PLAN COMMISSION MEETING AGENDA Thursday, April 4, 2024 at 6:00 P.M.

REPORT TO THE PLAN COMMISSION

Project Name:	StorageMart Special Use and Site Plan	
Project Address/Tax Key:	Not Assigned / 747 9992 005	
Property Owner:	TKG III Acquisition LLC	
Applicant:	TKG III Acquisition LLC	
Aldermanic District:	District 6	
Zoning District:	B-5 Highway Business District	
Staff Planner:	Nick Fuchs, Planning Associate

- From: Department of City Development Régulo Martínez-Montilva, AICP, CNUa, Principal Planner
- RE: Boomtown LLC, Certified Survey Map (CSM) 11607 W. Ryan Road

PROPOSED PHOTOMETRIC LIGHT LEVEL CALCULATIONS PLAN, GENERAL NOTES, AND LIGHT FIXTURE TABLE

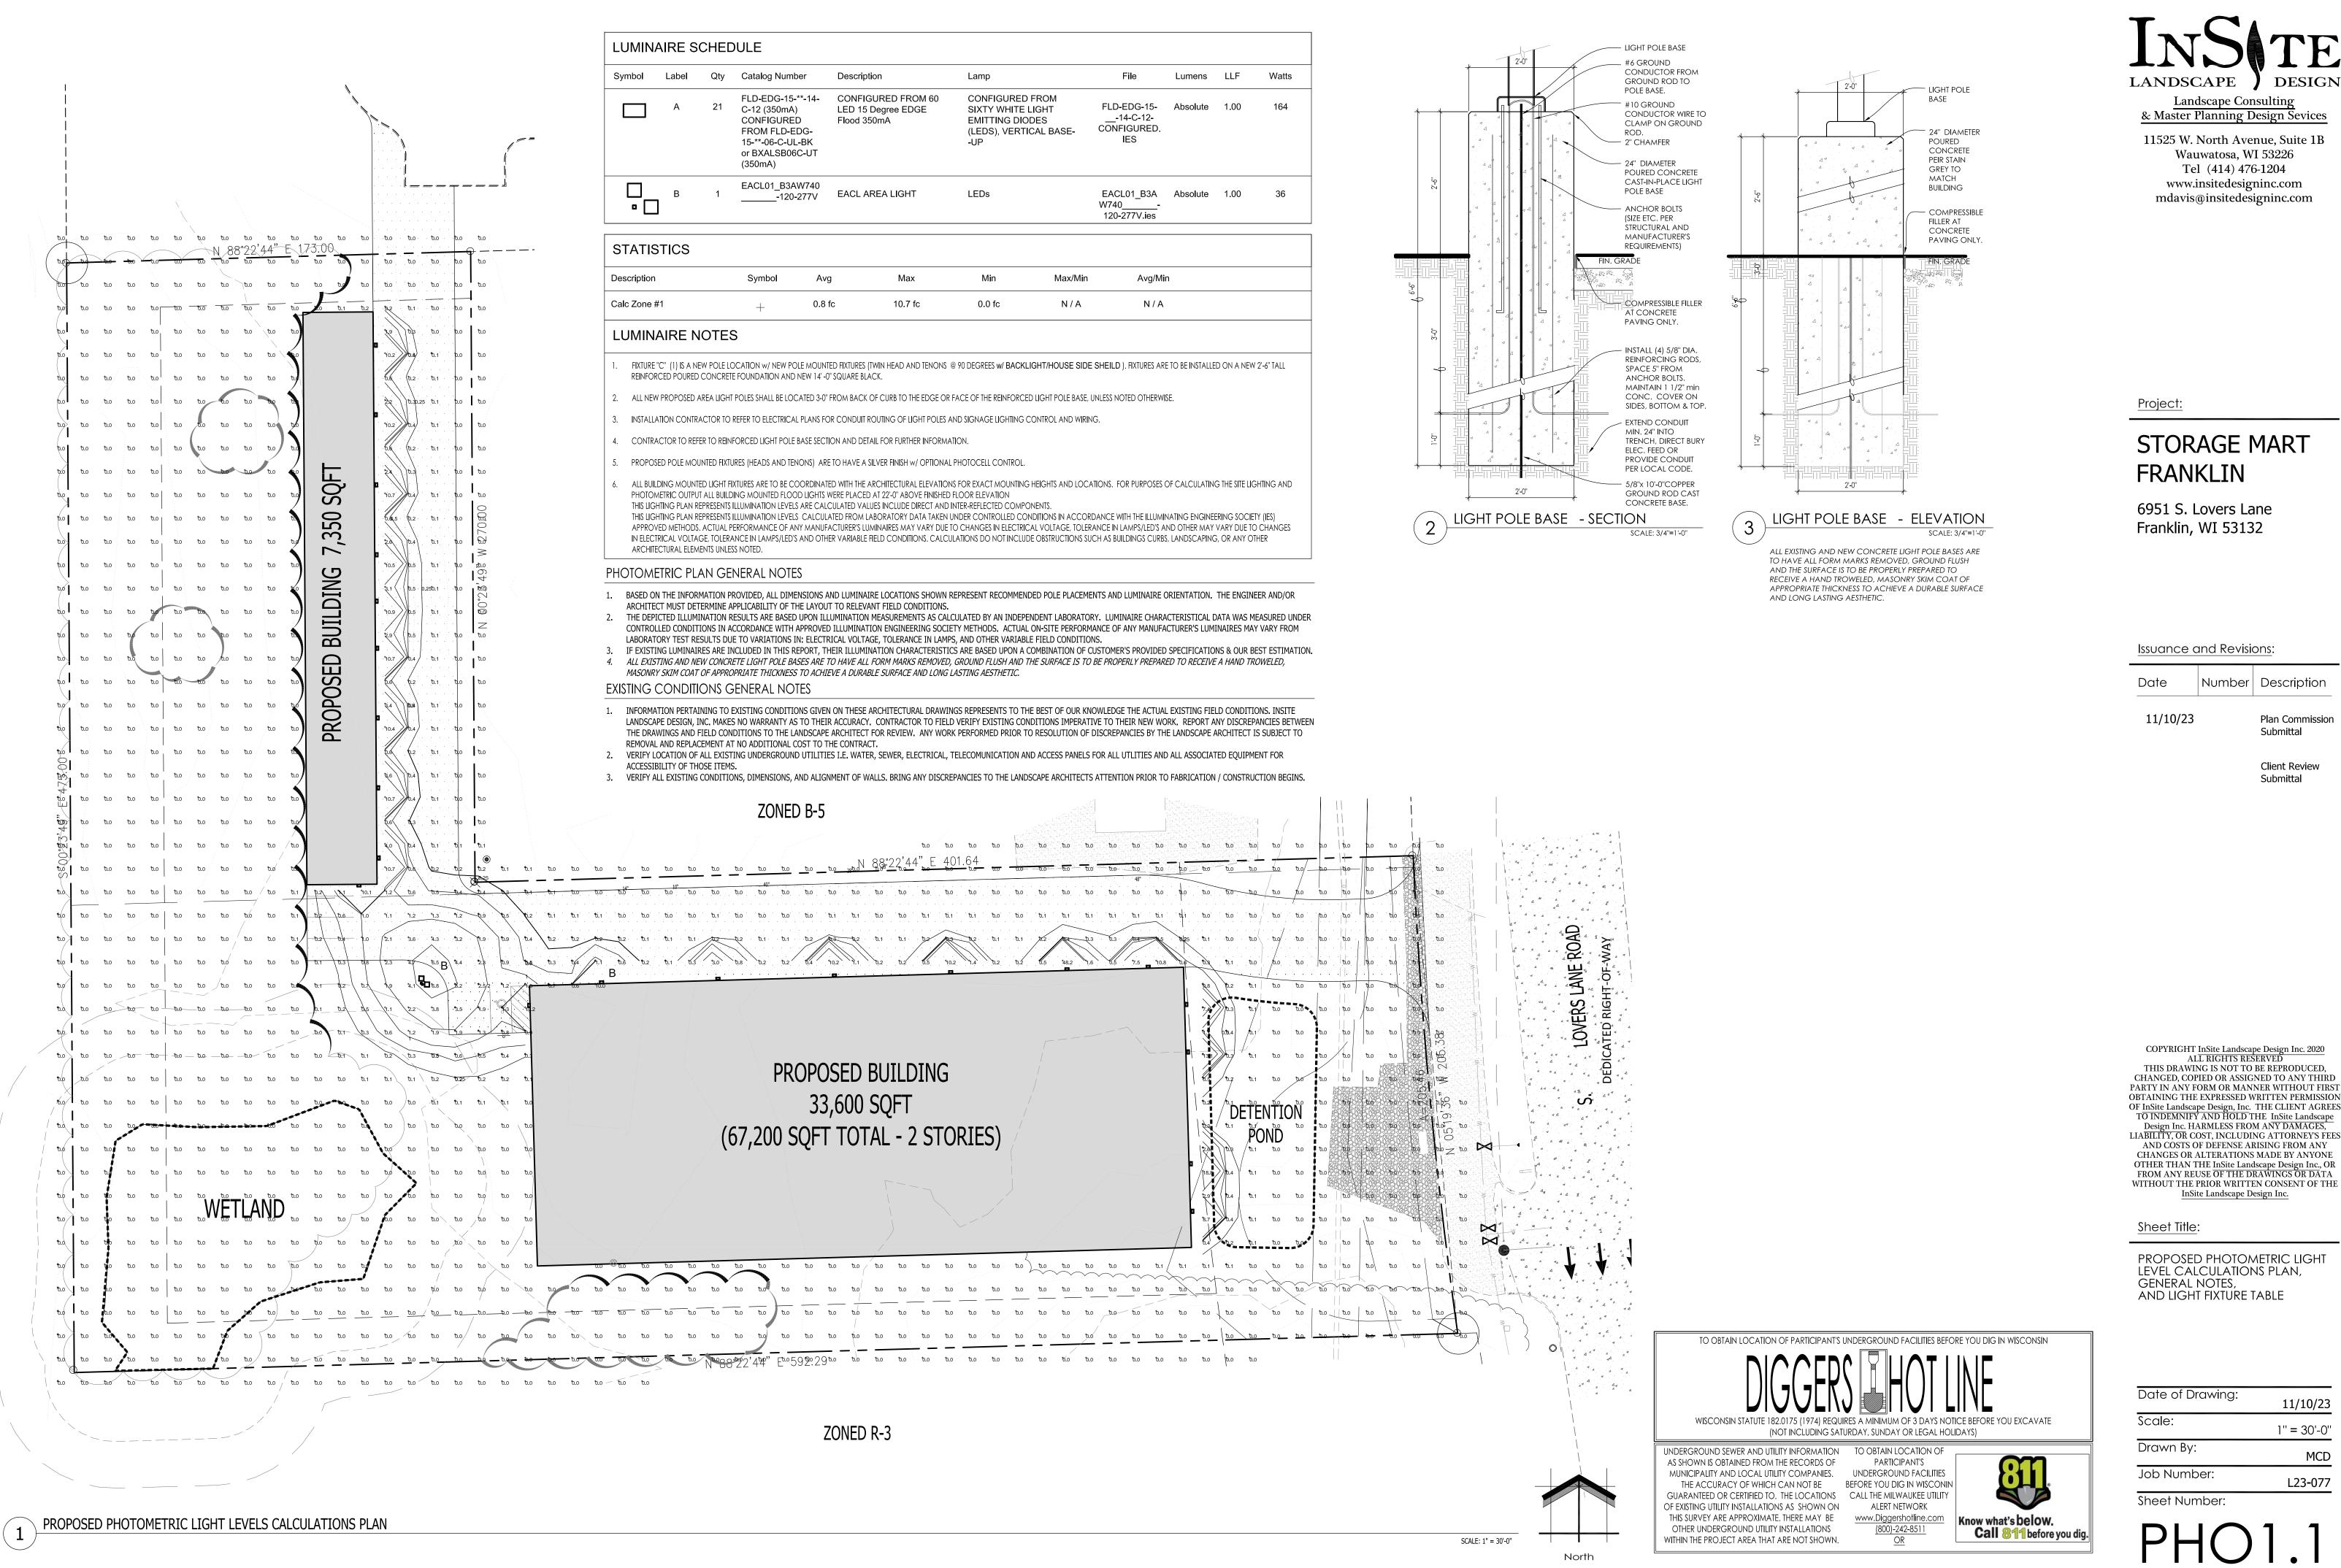
The applicant has provided a Lighting Plan with photometrics as well as cut sheets for all lighting provided. The Lighting Plan provides one light pole and twenty-one building lights. The light pole is located adjacent to the provided parking between the two buildings.

The Lighting Plan does not include lights that are directed towards adjacent residential uses. Footcandle levels are at 0.0 at the property lines.

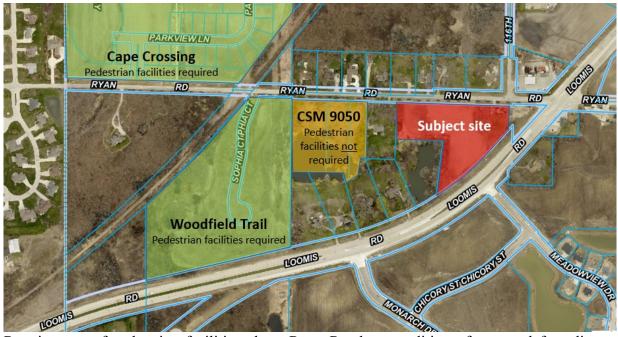
• **On-street pedestrian facilities** (comment #11). Based on the Comprehensive Master Plan, Map 7.4 Bicycle and Pedestrian Circulation Facilities. City Development staff recommends the installation of a pedestrian path per City of Franklin specifications on the south side of Ryan Road along the entire frontage of the site.

<u>Applicant's request:</u> "The Applicant requests clarification on the Pedestrian Facilities comment. The Comprehensive Plan Map referenced in Staff Comments clearly shows a "on-street" pedestrian facility. There are no existing pedestrian facilities in this area. We are opposed to the Staff recommendation requiring the installation of pedestrian facilities that do not have any connection point. Further, the applicant completed a Certified Survey Map 175' west of the subject property. That particular CSM did not require a pedestrian facility". March 1, 2024.

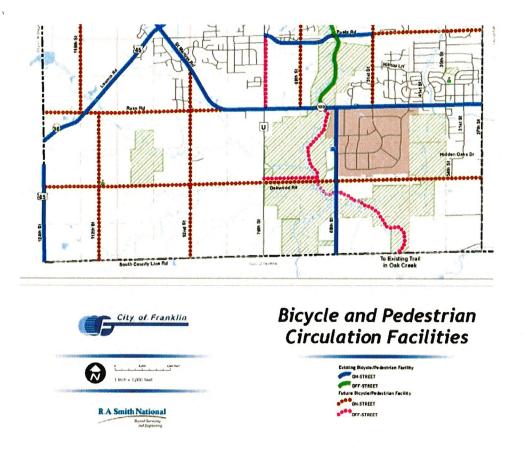
9. **Public water and sewer.** All new lots in the R-3 zoning district must be served by public sanitary sewer and water supply facilities pursuant to UDO §15-3.0203. Please add a note to the CSM to confirm that all four lots will be served by public sanitary sewer and water supply facilities, if that's the case.

The Certified Survey Map has been revised to include the notes regarding public utilities.

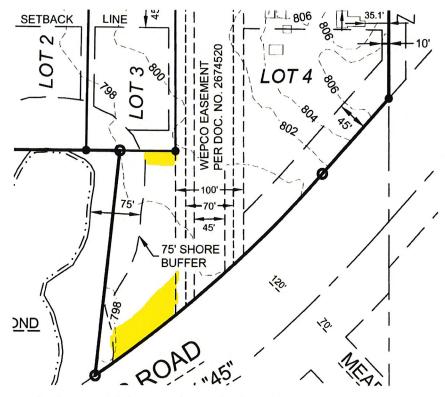
12. Setbacks. Pursuant to UDO §15-7.0702B, add setback lines to the south portion of Lot 4, specifically the 10-foot side setback (north) and 45-foot setback from Loomis Road, see below:

The revised CSM addresses the Setback Comment
